| Project Title: | Willow Rock Energy Storage Center |
| Document Title: | Willow Rock CURE Data Request Set 1 Response |

Willow Rock Energy Storage Center (21-AFC-02)

California Unions for Reliable Energy (CURE) Data Request Response Set 1

Figure 9 from BRAR Addendum

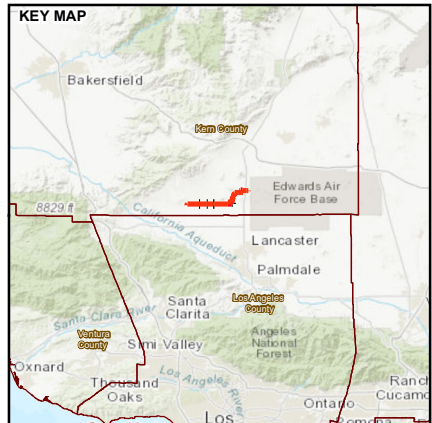
DR62: *Provide a copy of Figure 10, as referenced on page 47 of the BRAR Addendum (TN 258316).*

Response: Figures 9 and 10 were both inadvertently omitted from the August 2024 Willow Rock Energy Storage Project Biological Resources Assessment Report (TN# 258316). Figures 9 and 10 from the Biological Resources Assessment Report are provided as **Attachments DR62-1a and DR62-1b**.

Figure 10 from BRAR Addendum

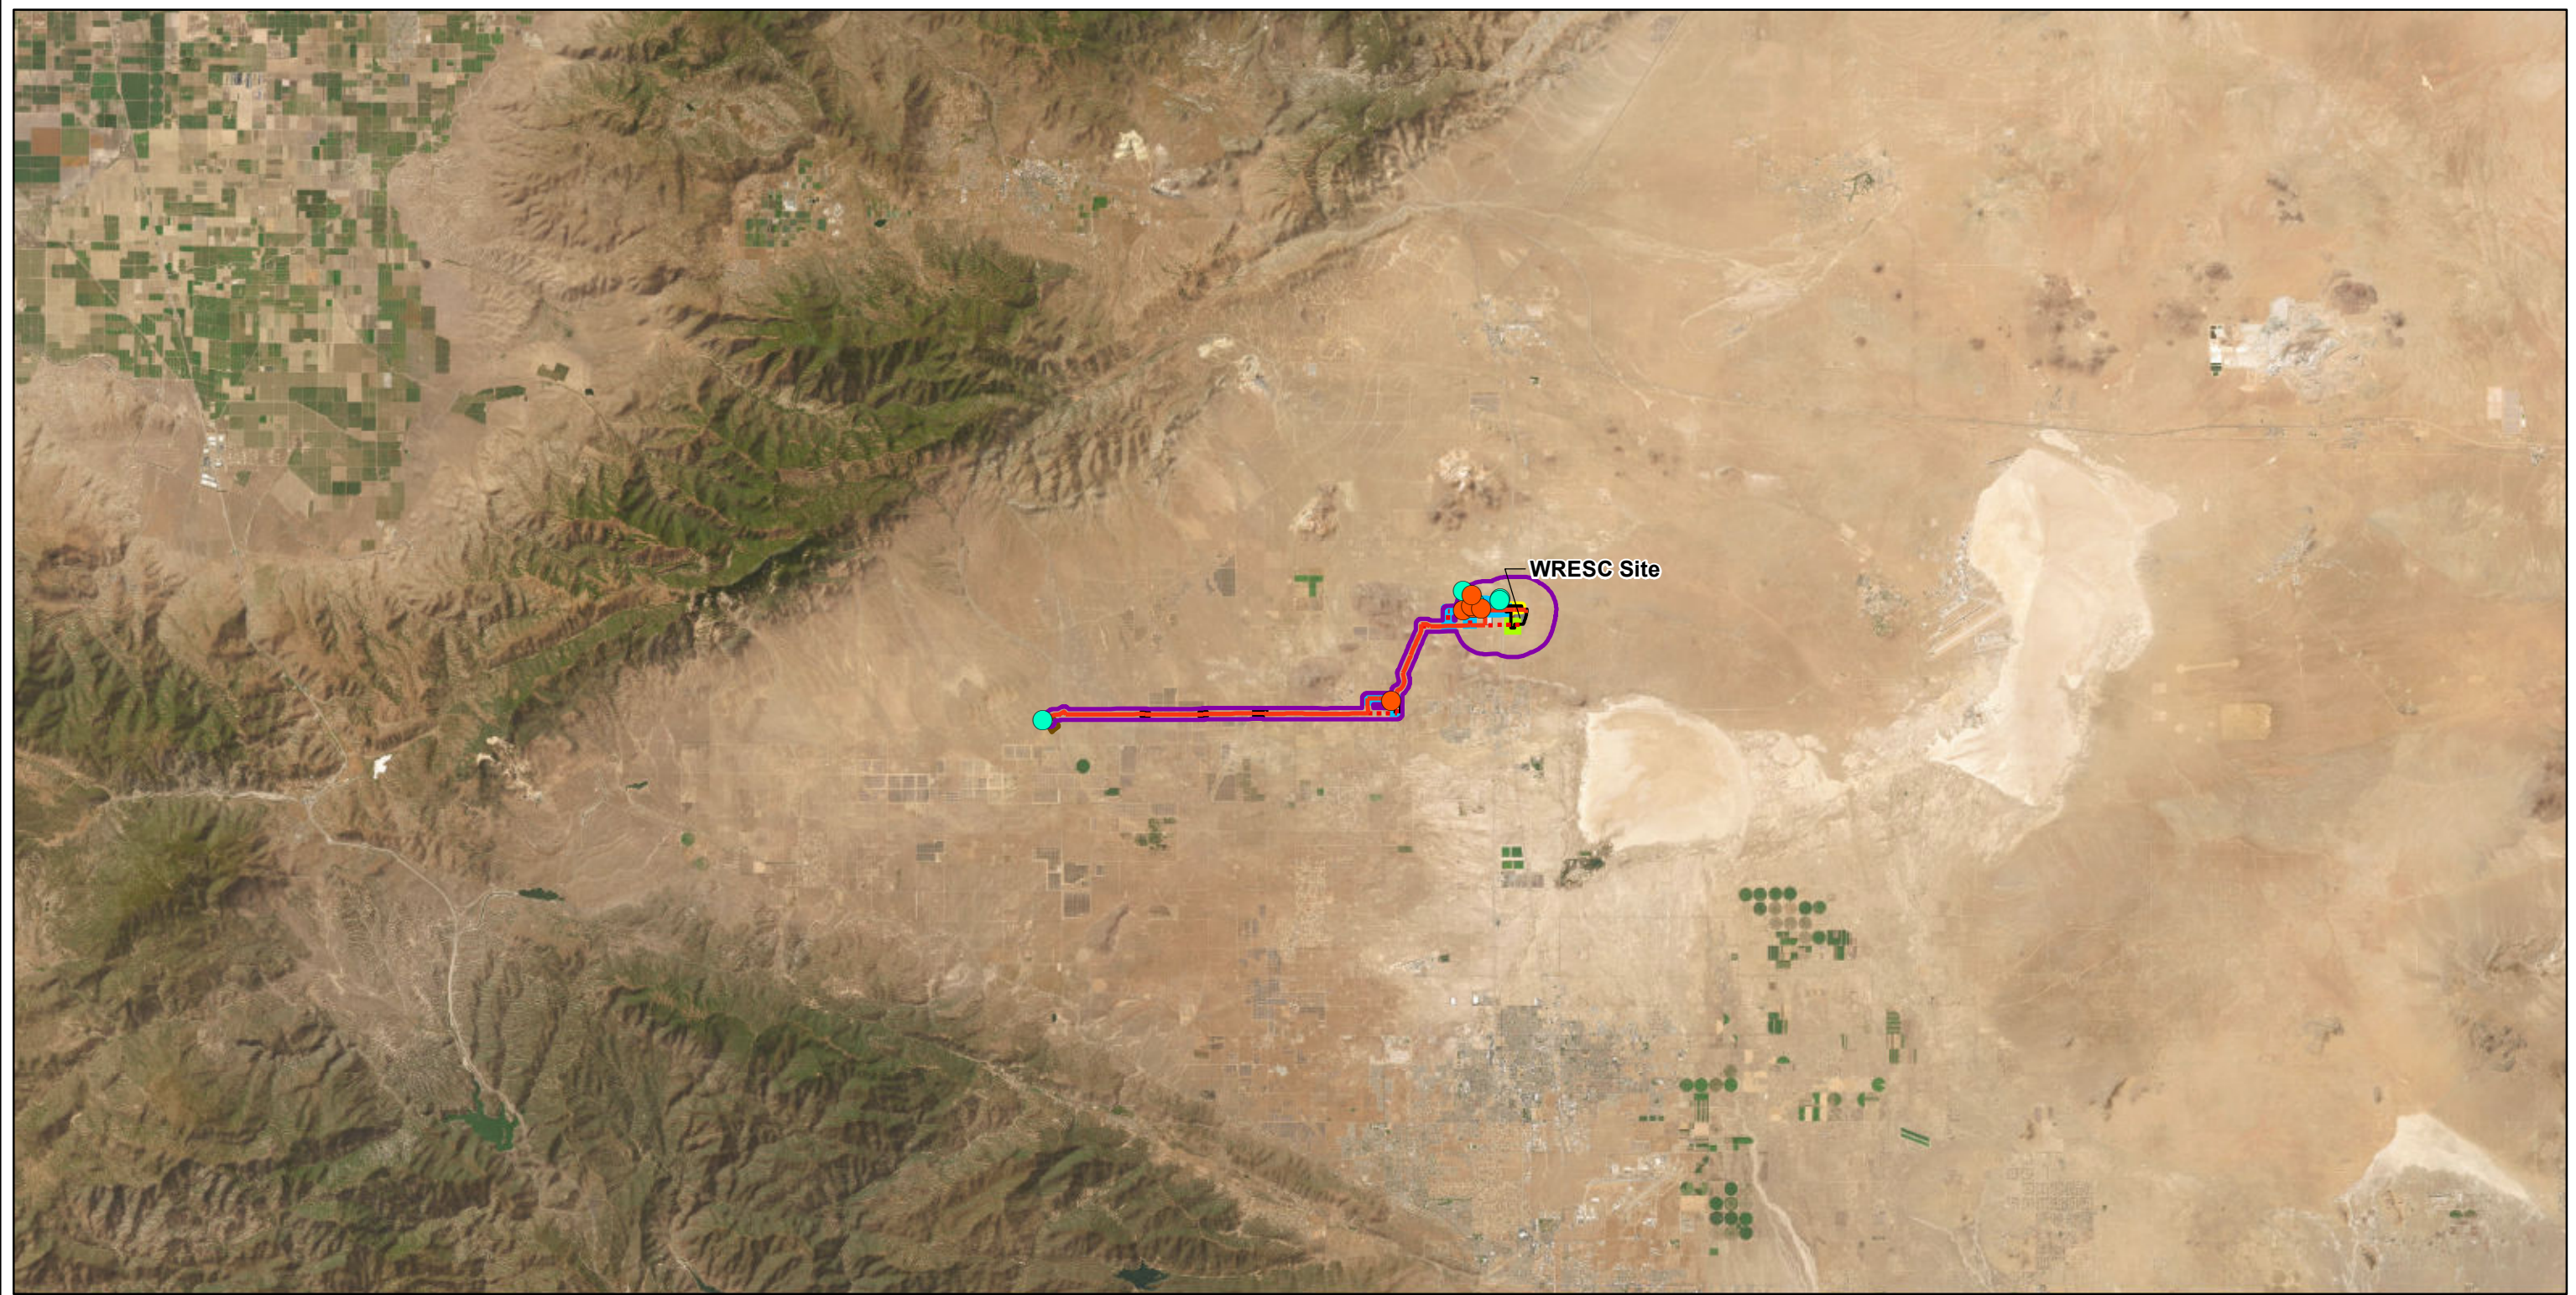
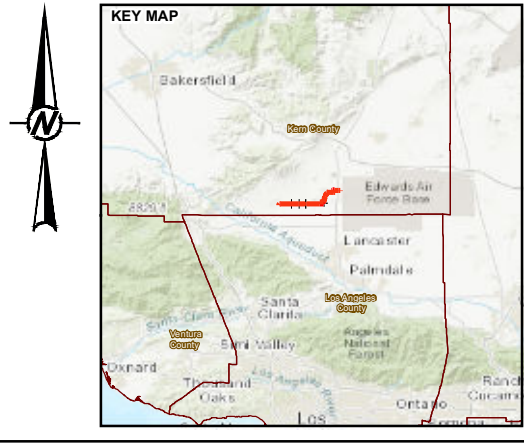
The BRAR Addendum states: “Swainson’s hawk are known to have an active nest 7 miles west of the project site. Since the project area is not within 5 miles of the nest, no mitigation measures are required for foraging habitat impacts.” (TN 258316 at p. 53) The BRAR Addendum provides the following discussion of the active nest: “[o]n June 5, 2024, a pair of Swainson’s hawks were documented near the nest reported by WSP during the desert tortoise survey (2024c), which is located off site (Figure 10).” (*Id.* at p. 47) However, according to the Desert Tortoise Survey 2024 Addendum (Table 1), no desert tortoise surveys were conducted on June 5, 2024 (they concluded on April 9, 2024) and the Addendum has no mention of the Swainson’s hawk nest. Also, the nest is located approximately 1.5 miles from the Project’s gen-tie line route, which means it is 1.5 miles from the Project area. (TN 254806 at p. 5.2- 33) Finally, Figure 10 is omitted from the BRAR Addendum.
